Re: FortisBC Energy Inc. – Application for a Certificate of Public Convenience and Necessity for the Pattullo Gas Line Replacement Project – Project No. 1599129 – BCUC Decision and Order C-2-21

Application for a Certificate of Public Convenience and Necessity for the Pattullo Gas Line Replacement Project

Decision and Order C-2-21

Figure 4-1: Trunk Distribution System Capacity

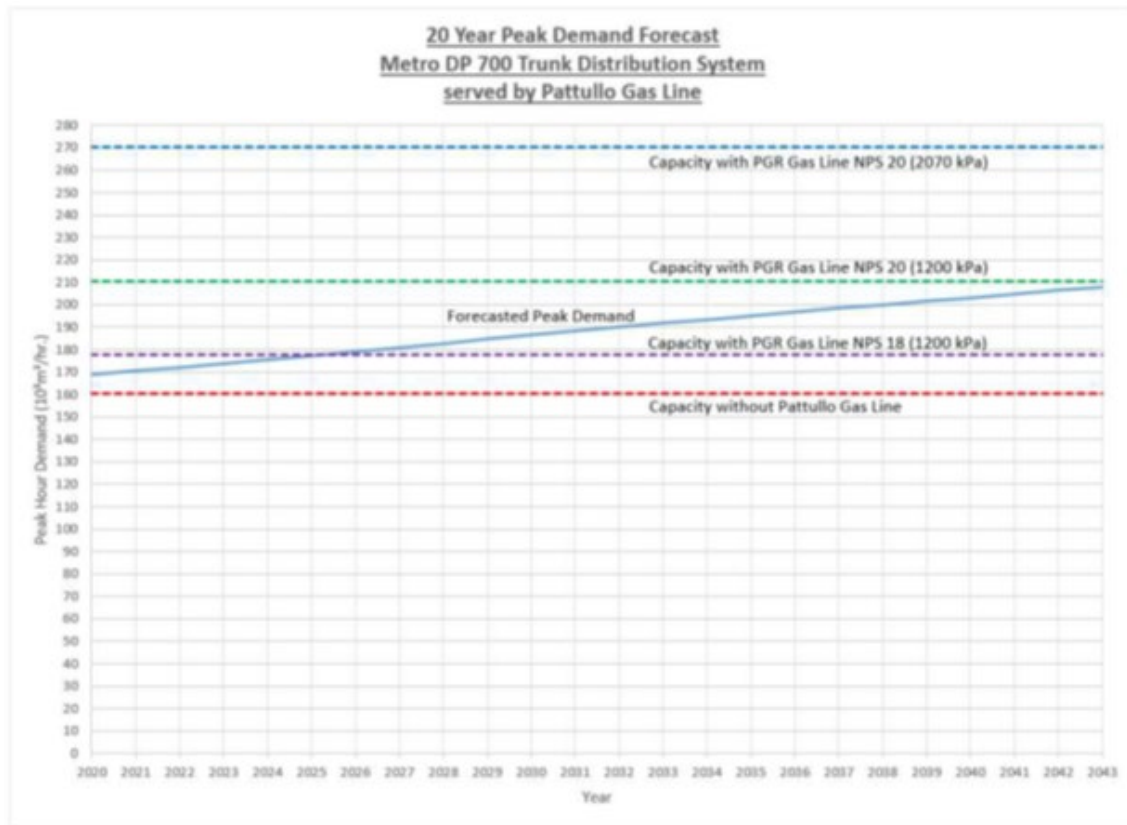
FEI provides Figure 4-1 showing that an NPS 20 gas line would have sufficient capacity to meet customer demand to the end of the 20-year planning horizon, while the next smallest pipe size, NPS 18, would only have sufficient capacity to meet customer demand until 2025.⁷⁶

The CEC submits that it is appropriate to plan for future capacity increases as proposed and “supports FEI’s project scope as being reasonable.”⁷⁸

Figure 4-2: FEI's Preferred Pipeline Route for the Project

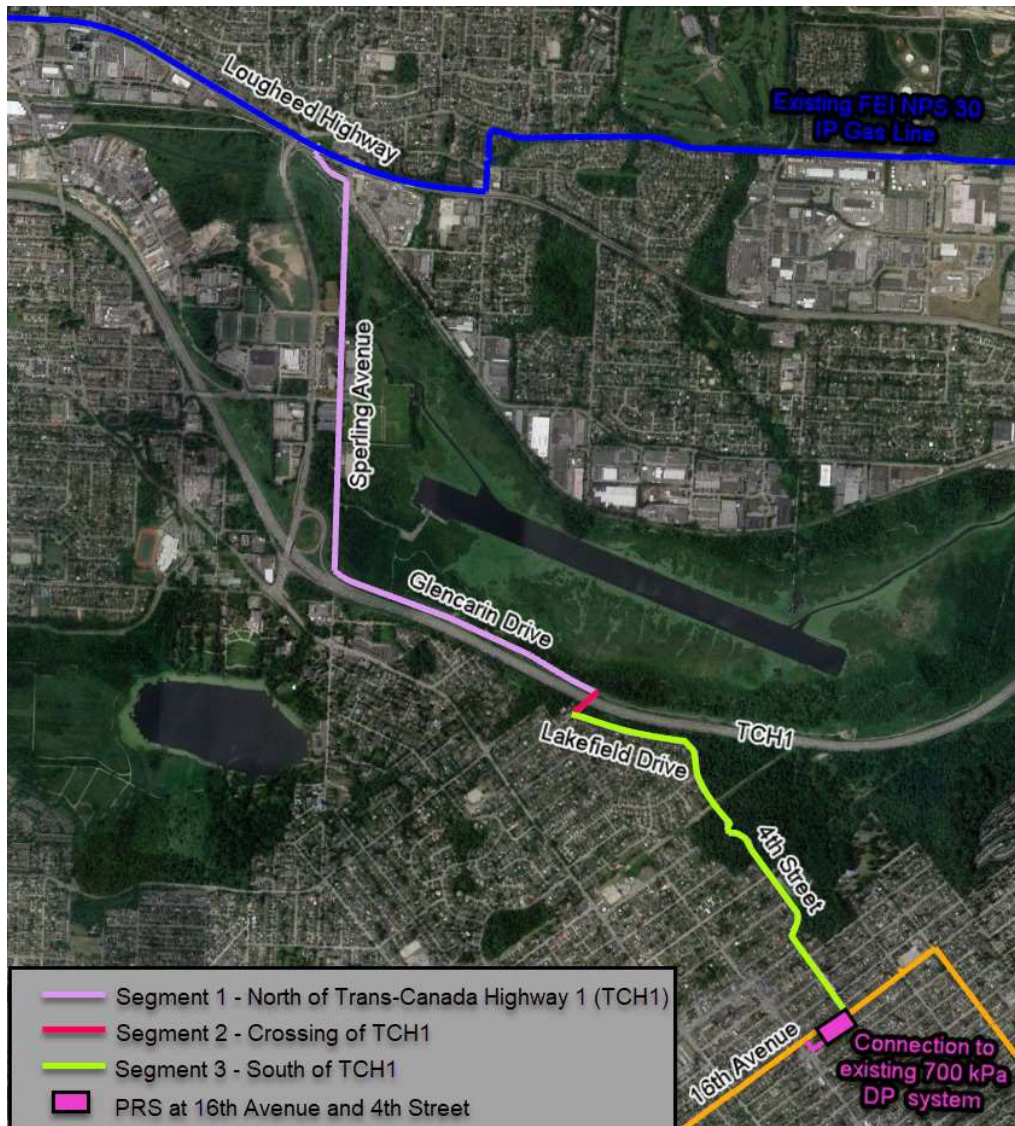
FEI is requesting approval of a CPCN to construct and operate the PGR Project pipeline along its preferred route, as shown in Figure 4-2 below.⁷⁹

FEI states that it plans to finalize the pipeline route within the Sperling Route corridor during the detailed design phase of the PGR Project, which is scheduled for completion after close of the evidentiary record in this proceeding. The final route alignment will reflect consultation, environmental, and technical considerations and is a required deliverable for an AACE Class 3 cost estimate for the PGR Project.⁸⁰

FEI proposes that if there is a material change to the preferred route within the Sperling Route corridor (i.e. a portion of the gas line cannot be constructed in the approved route), it will file an application (and supporting justification) for approval from the BCUC to modify the route at least 90 days before construction is proposed to commence. FEI submits that this approach “will provide the BCUC an opportunity to assess the revised Project route, and is consistent with the BCUC’s direction to FEI in its Decision and Order C-11-15 granting a CPCN for FEI’s Lower Mainland Intermediate Pressure System Upgrade (LMIPSU) projects.”⁸¹

BCOAPO questions the need for FEI to wait until as late as 90 days before the commencement of construction to notify and file an application with the BCUC to approve a material change in the proposed route alignment. As a result, BCOAPO recommends that the BCUC direct FEI to report on any material changes to the proposed routing within 30 days of the date on which the material change occurs.⁸²

The Panel considers it reasonable in this instance for FEI to proceed with its detailed design of the pipeline route following the close of the evidentiary record. The Panel accepts that FEI’s efforts during the detailed design may identify the need for changes to the preferred route. The Panel agrees with BCOAPO that if FEI determines a material change to the route is necessary that it must file a CPCN application with supporting justification for BCUC approval.

The Panel is concerned with FEI filing such an application only 90 days prior to commencement of construction, as it will provide a very short window for BCUC review. Accordingly, **the Panel directs FEI to file any Notification of a Material Change for an alternative route within 30 days of identifying the need for the alternative route and a CPCN application at least 90 days before construction begins.**
